**From:** Scala, Mary Joy  
**Sent:** Wednesday, June 04, 2014 12:27 PM  
**To:** 'Keith Woodard'  
**Subject:** BAR Action May 20, 2014 - 104 1st Street N

**RE: Certificate of Appropriateness Application**  
BAR 14-04-03  
104 1<sup>st</sup> Street North  
Tax parcels 330244000 and 330245100  
First & Main Charlottesville, LLC, Owner/Keith O Woodard, Applicant  
First/Market parking lot: add fencing, lighting, landscaping

**CITY OF CHARLOTTESVILLE  
BOARD OF ARCHITECTURAL REVIEW  
STAFF REPORT  
May 20, 2014**

BAR 14-04-03

Lighting Layout  
 Version B

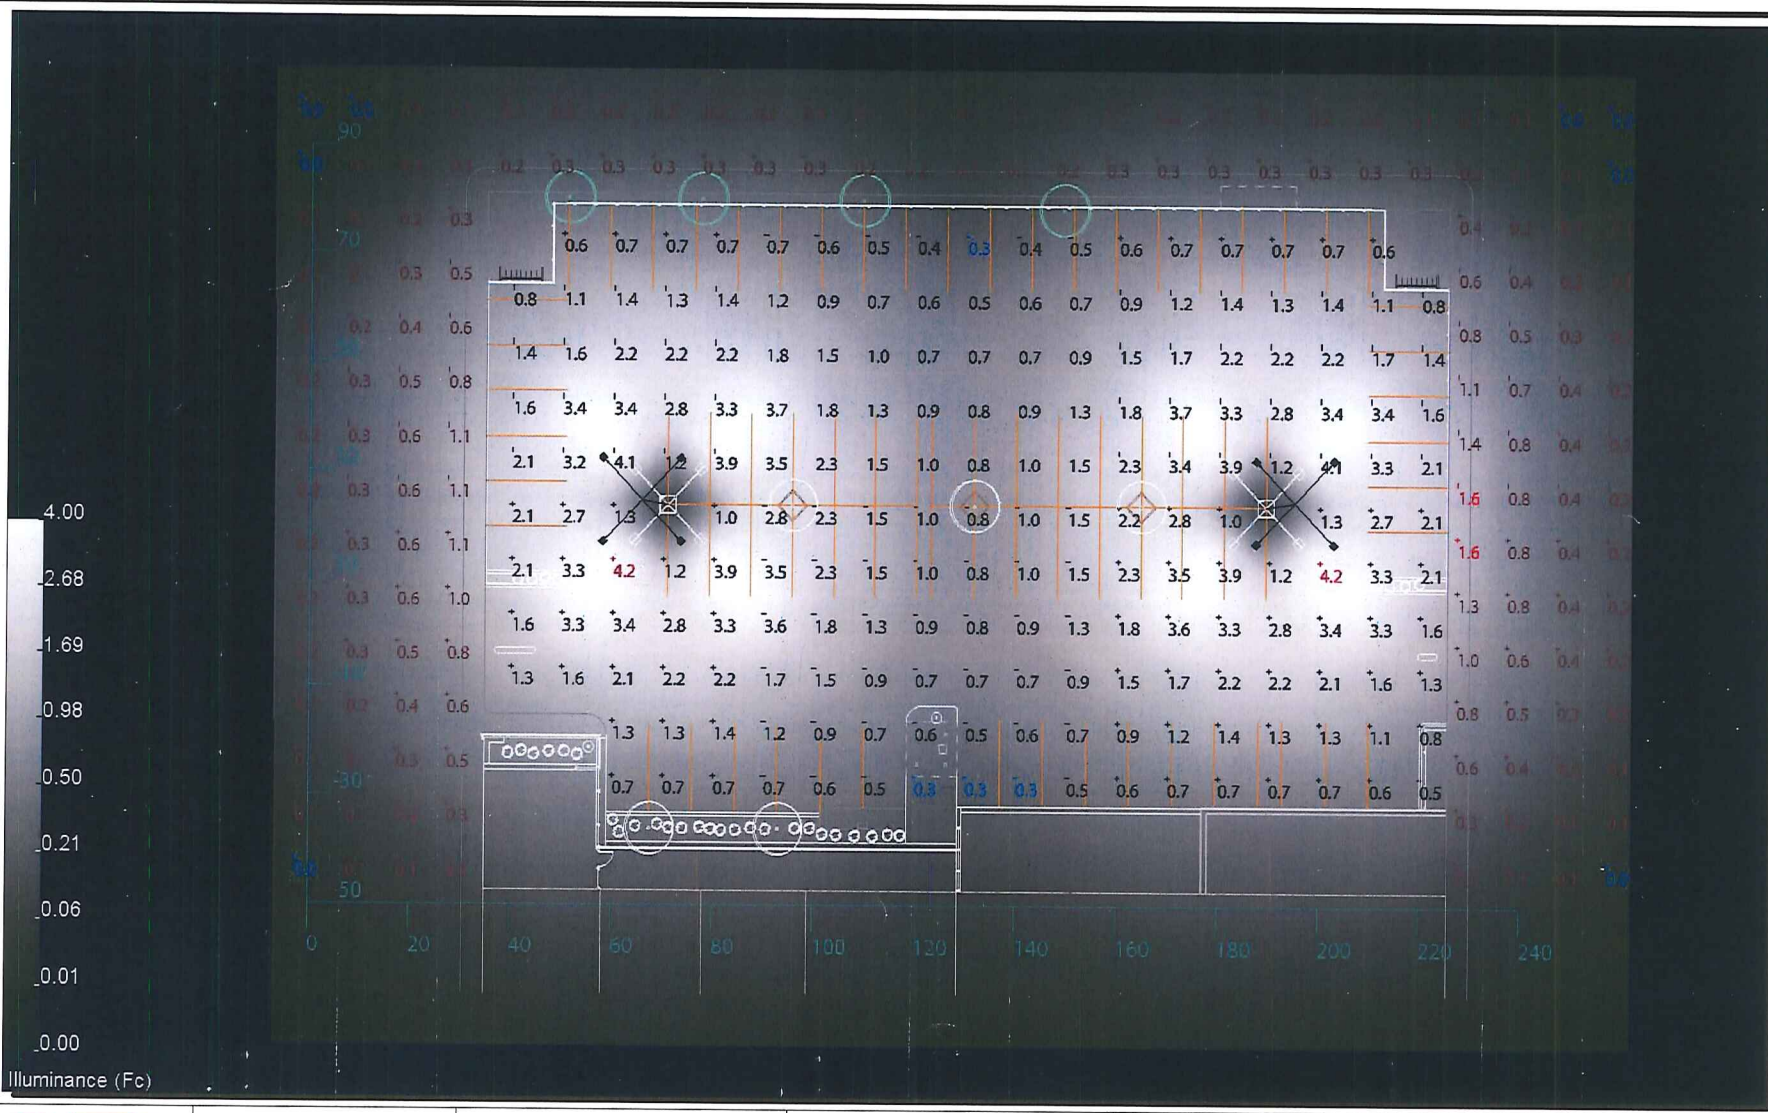
April 15, 2014 – Accepted (7-0) applicant's deferral request. The BAR wants more information regarding material surface under bike racks; photometric plan and assurance that lighting will not cause glare; plan for soil preparation for trees.

- A photometric plan that shows fairly low and even levels of lighting from new fully shielded light fixtures located on two new poles;
- Tree and shrub planting guidelines from Virginia Cooperative Extension that will be used as a standard for the new plantings proposed on site;
- A site layout that shows the location of 5 new Zelcovas and ~~one~~<sup>2</sup> new Dogwood<sup>s</sup> to be planted;
- A detail sheet that shows turfstone permeable pavers as the material surface under the bike racks, a new planted border with liriopse, and a black aluminum fence to be used consistently around the site.

**Approved as submitted (8-0) except trees and planting details to be approved administratively after circulating details to BAR by email.**

These improvements are positive and appropriate. The applicant has submitted all the information that was requested.
